# Access Compliance Report

## Public Rights-of-Way

Intersection ID: 12400	Main Street: BELVEDERE_AV	Cross Street: ST_ANDREWS_LN	Location: SW
ADA ID: CAB71B31EE04	Ramp Type: Perp	Initial Pass/Fail: Fail	Overall Compliance: No
Severity Score: 8.75			
Codes/Mitigation Info/Possible Solution		Field Measurements/Component Compliance

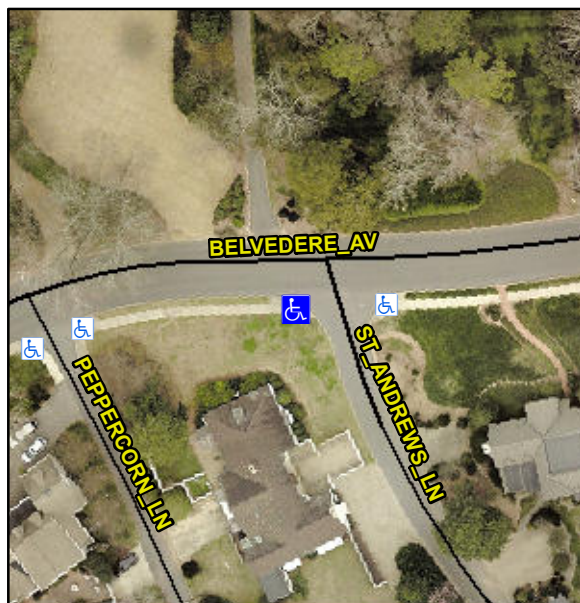
**Remove & Replace Entire Ramp.**

**R304.5.1**

Compliance	Description	Data	Compliance	Description	Data
N/A	Ramp Length (in)	66.5	Yes	Ramp Slope (%)	7.2
No	Ramp Width (in)	40.0	Yes	Ramp XSlope (%)	1.3
N/A	Flare Type LT	N/A	N/A	Flare Type RT	N/A
N/A	Flare Slope LT (%)	N/A	N/A	Flare Slope RT (%)	N/A
N/A	Flare Traversable LT?	N/A	N/A	Flare Traversable RT?	N/A
N/A	Landing Length (in)	N/A	N/A	DWS Provided?	N/A
N/A	Landing Width (in)	N/A	N/A	DWS Contrast?	N/A
N/A	Landing Slope (%)	N/A	N/A	DWS Length (in)	N/A
N/A	Landing X Slope (%)	N/A	N/A	DWS Full Width?	N/A
N/A	Landing Curb? (Y/N)	N/A	N/A	DWS Offset (in)	N/A
N/A	Shared Landing?	N/A			
N/A	Gutter Ponding?	N/A	N/A	Gutter Slope (%)	N/A
N/A	Gutter Lip Ht (in)	N/A	N/A	Gutter X Slope (%)	N/A
N/A	Painted X Walk1?	No	N/A	Painted X Walk2?	N/A
	X Walk 1 Direction	To E		X Walk 2 Direction	N/A
N/A	X Walk 1 Width (in)	N/A	N/A	X Walk 2 Width (in)	N/A
	X Walk 1 Slope (%)	3.8		X Walk 2 Slope (%)	N/A
	X Walk 1 X Slope (%)	1.2		X Walk 2 X Slope (%)	N/A
